HL-1359  
006127

PLANT HATCH - UNITS 1, 2  
NRC DOCKETS 50-321, 50-366  
OPERATING LICENSES DPR-57, NPF-5  
REQUEST FOR ADDITIONAL INFORMATION:  
SUPPRESSION POOL TEMPERATURE MONITORING

PLANT HATCH - UNITS 1, 2  
... SOCKETS 50-321, 50-366  
OPERATING LICENSES DPR-57, NPF-5  
REQUEST FOR ADDITIONAL INFORMATION:  
PREPLANNED ALTERNATE METHODS FOR  
SUPPRESSION POOL TEMPERATURE MONITORING

FIGURE 1  
POOL TEMPERATURE DURING RCIC TESTING

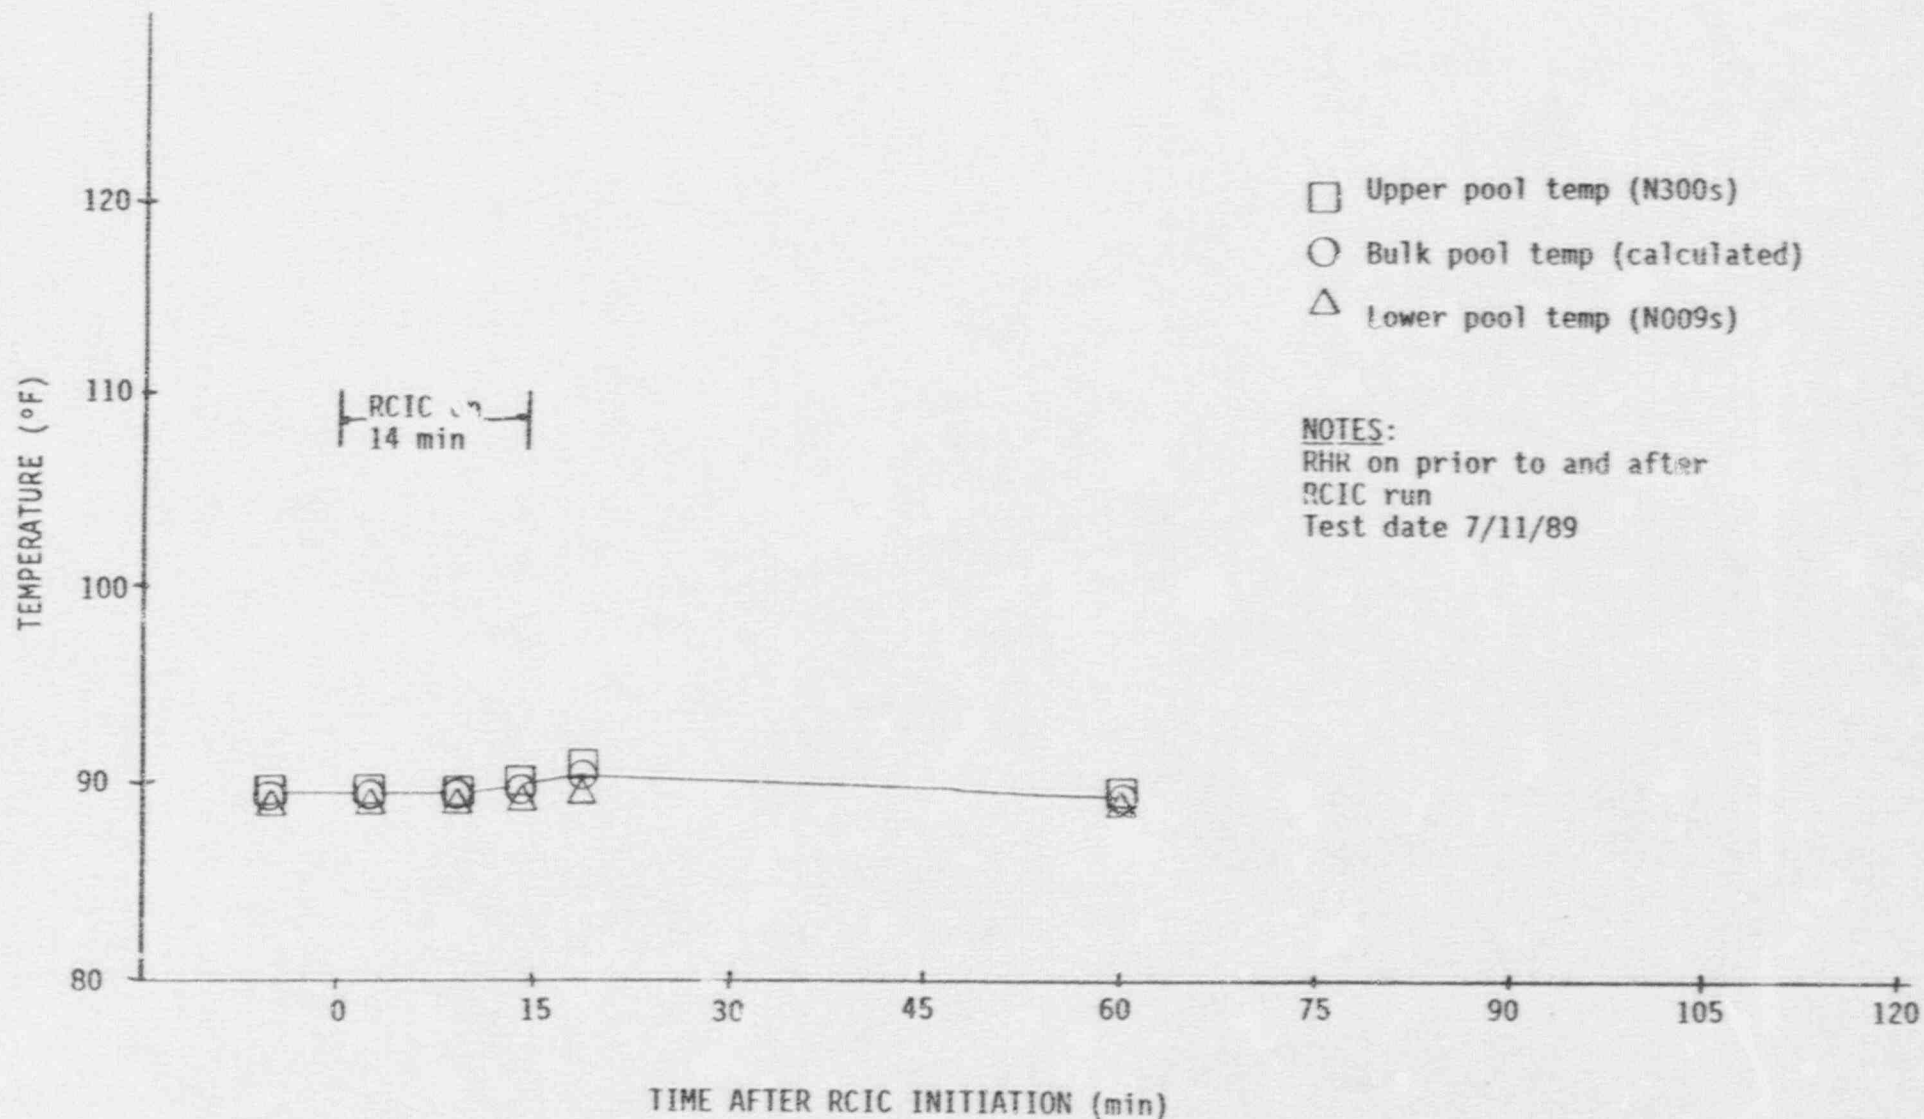
During normal operation, the temperature differential between the average of the N009 Series elements and the bulk pool temperature is on the order of 1°F or less. SRV testing is very brief (a few seconds or less per valve), and pool heatup/stratification is not significant. During RCIC testing, the relatively low steam discharge mass flux (as compared to HPCI), in conjunction with the RHR System, can effectively minimize stratification. Figure 1, Pool Temperature During RCIC Testing, illustrates this point.

FIGURE 2

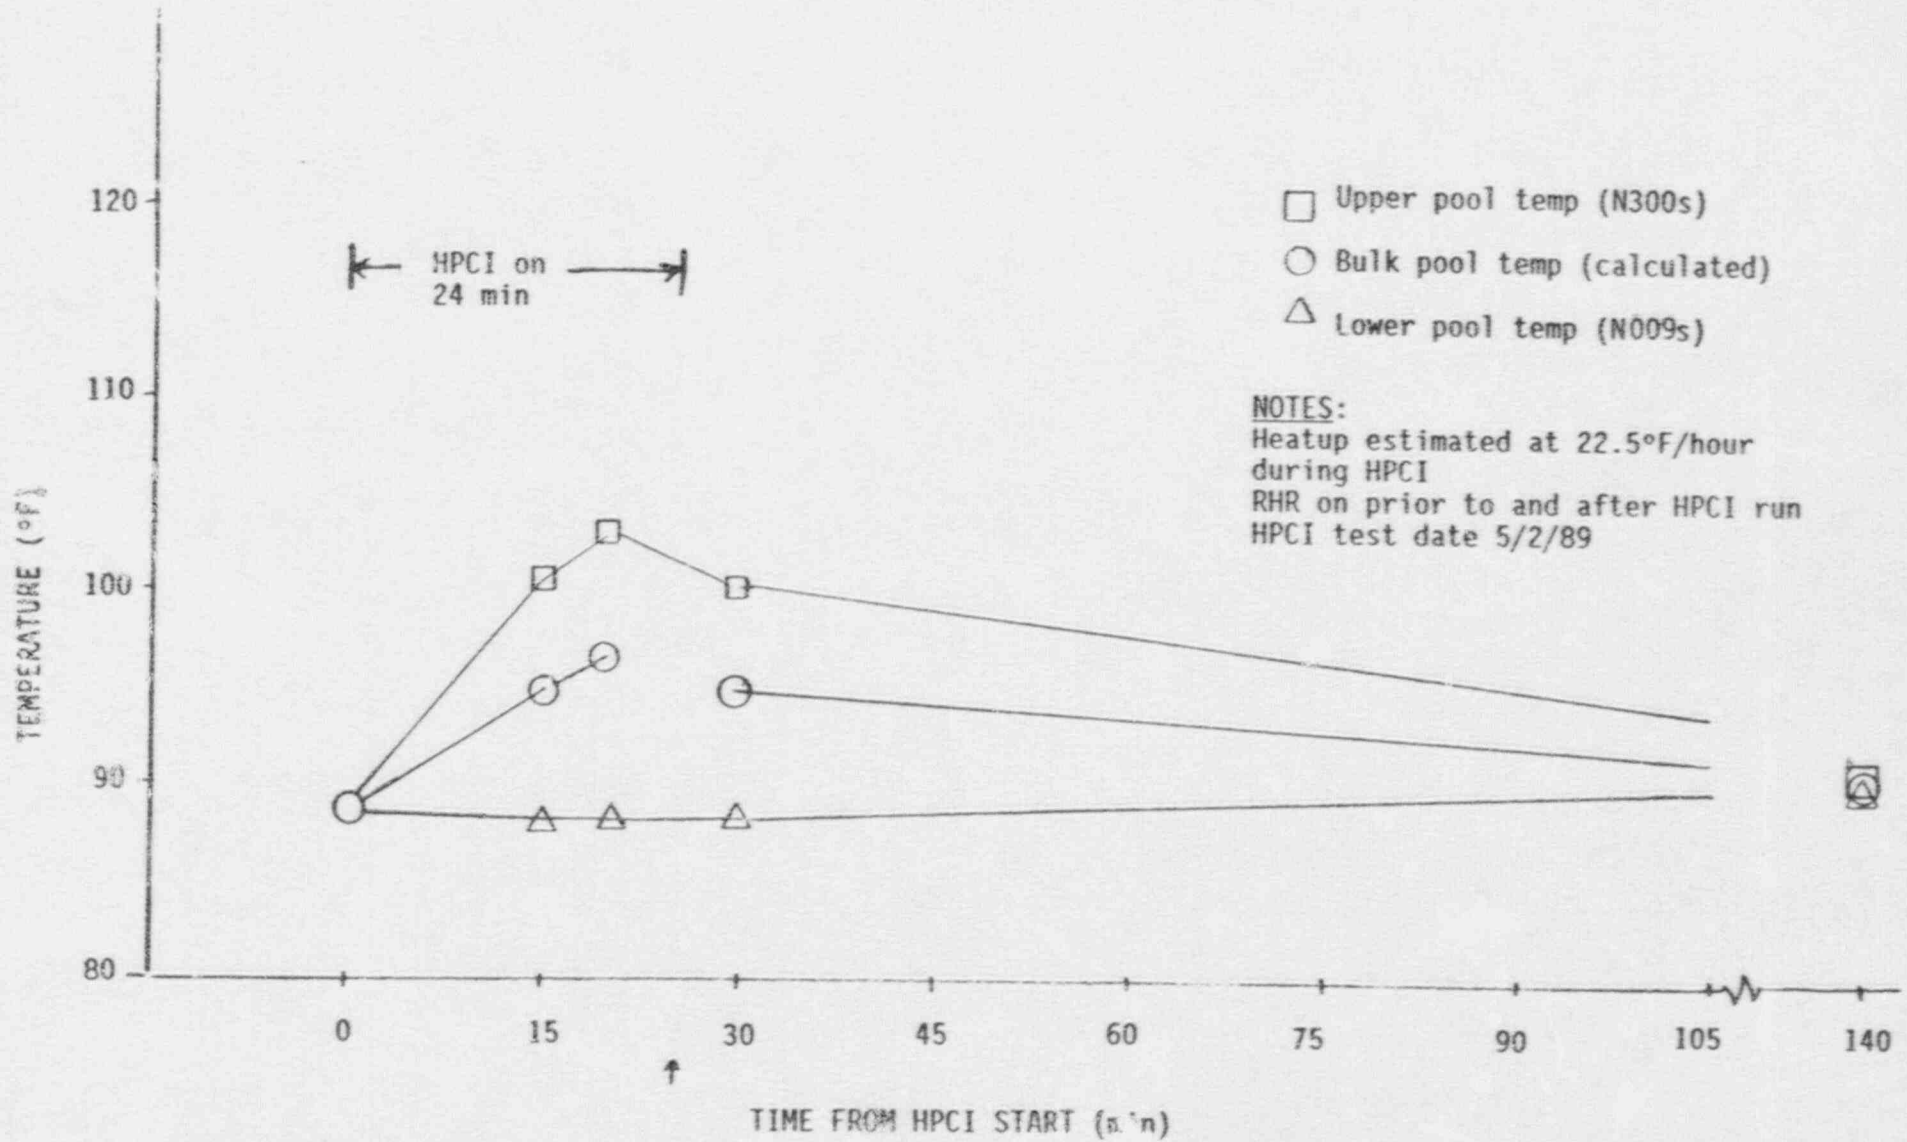
3. The HPCI System has approximately 10 times the steam flow of the RCIC System; therefore, during HPCI testing, thermal stratification may be significant. The N009 Series (lower elevation) sensors may not respond as quickly as the upper temperature sensors (N300 Series) and the N009 Series sensors alone may not give an accurate reading of bulk pool temperature. Figure 2, Pool Temperature During HPCI Testing, illustrates this point.

FIGURE 3

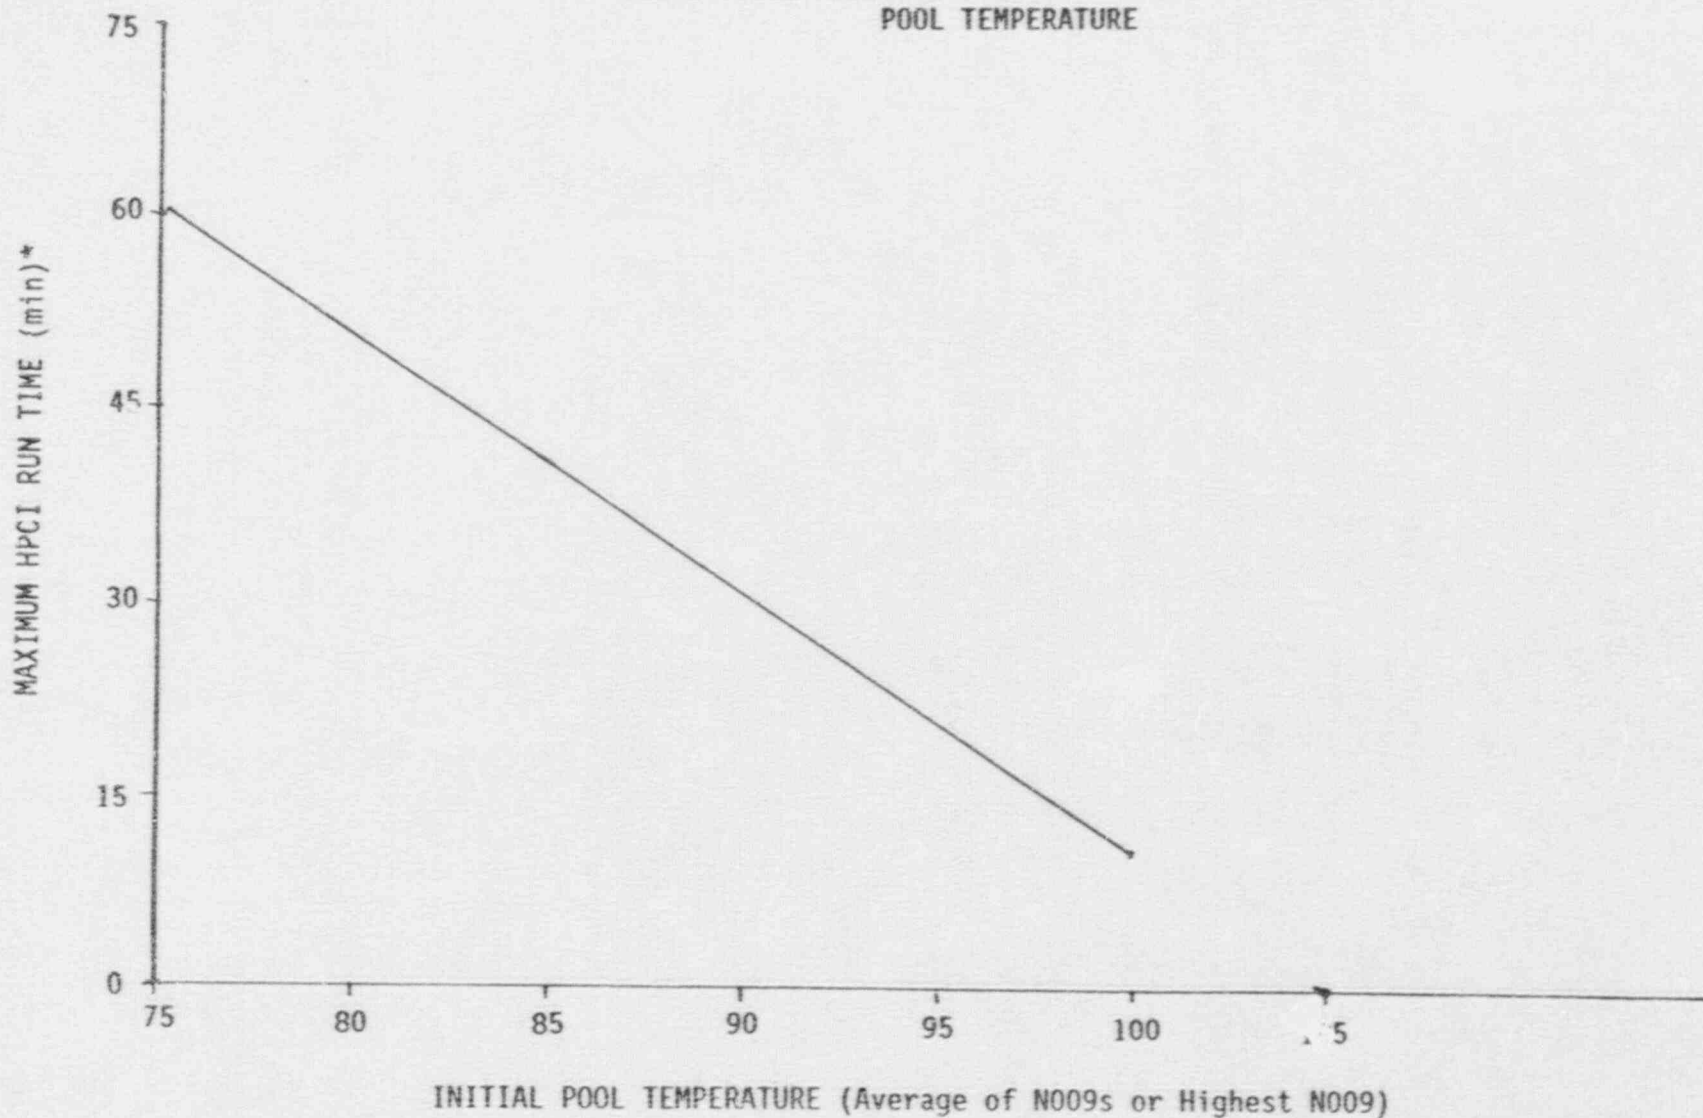
Figure 3, Permissible Run Time for HPCI Versus Initial Pool Temperature, is based on the observed heatup during testing and analytical calculations of bulk temperature increase. Since the RHR System is aligned in the SPC mode prior to running HPCI, an accurate bulk temperature measurement may be obtained prior to starting the test using only the lower pool temperature elements (N009 Series), if necessary. Plant personnel will continue to record the pool temperature every 5 minutes, as instructed by the TS; however, run time will be administratively limited when upper pool temperature indication is not available (i.e., more than 2 of the 11 N300 Series sensors are inoperable).
